### REVIEW AND CERTIFICATION LOG

DOCUMENT NAME:	Responses to RAI on Holtec Report HI-951389 for the D.C. Cook Spent Fuel Pool
HOLTEC DOCUMENT I.D. NUMBER:	971763
HOLTEC PROJECT NUMBER:	70851
CUSTOMER/CLIENT:	American Electric Power

"With regard to the spent fuel pool (SFP) cooling analyses for the normal refueling scenarios, Case 1A and 2 as presented in February 1, 1996 submittal are based on the spent fuel assemblies discharged from Unit 1 during Cycle 25A. Since Unit 2, will be operating at a higher power level than Unit 1 (3588 MWt vs 3250 MWt), the analyses for Case 1A and 2 should be revised based on the spent fuel assemblies discharged from the Unit 2 reactor during Cycle 20B. Also, Tables 3, 4 and 5, and Figures 1, 3, 6 and 8 should be revised to include the results from the above revised analyses."

FIGURE 5: Decay Heat Generation Rate for Each Discharge Batch In the Full Core  
Back-to-Back Discharge Case 3

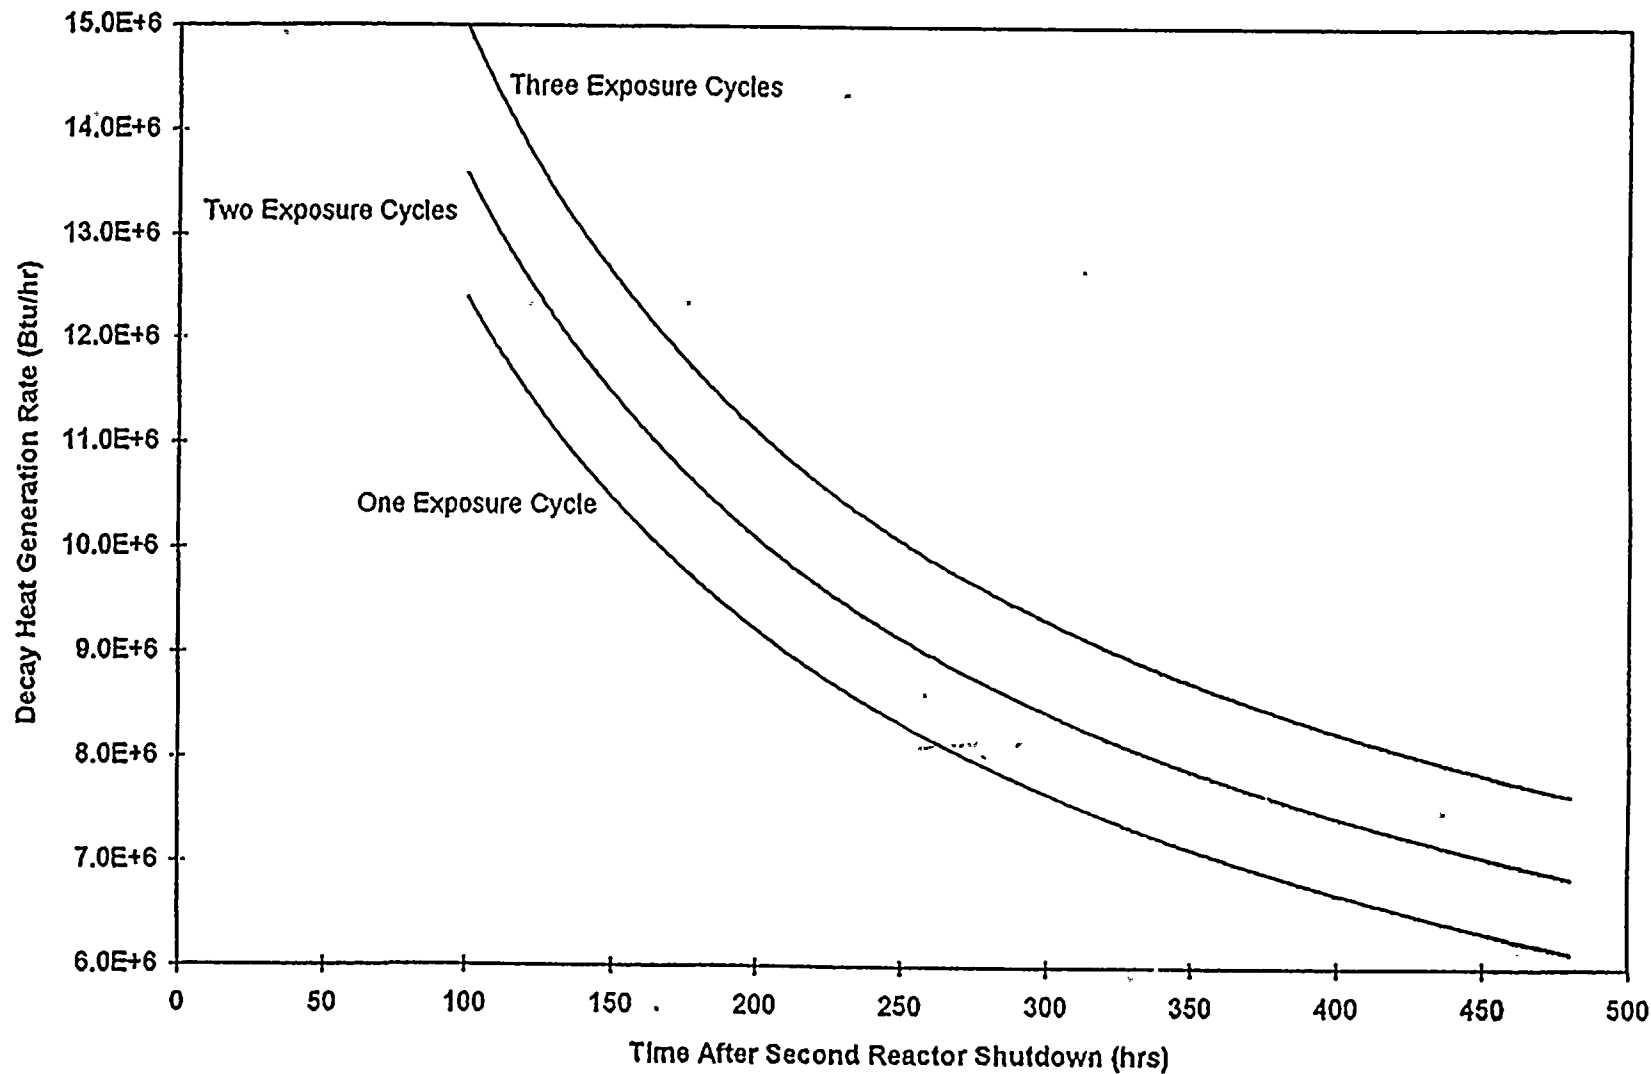
"In the analyses for the scenario of back-to-back full core discharge with two SFP cooling trains (Case 3), spent fuel assemblies from Unit 2 are assumed to be discharged in three groups each with a different burnup value. Provide curves to show the decay heat rates as a function of time generated in the SFP from each of these groups."

Figure 5 presents the decay heat profiles for each of the three groups of the full core discharge batch for Case 3. As expected, the decay heat generation rate and the reactor exposure are directly proportional.
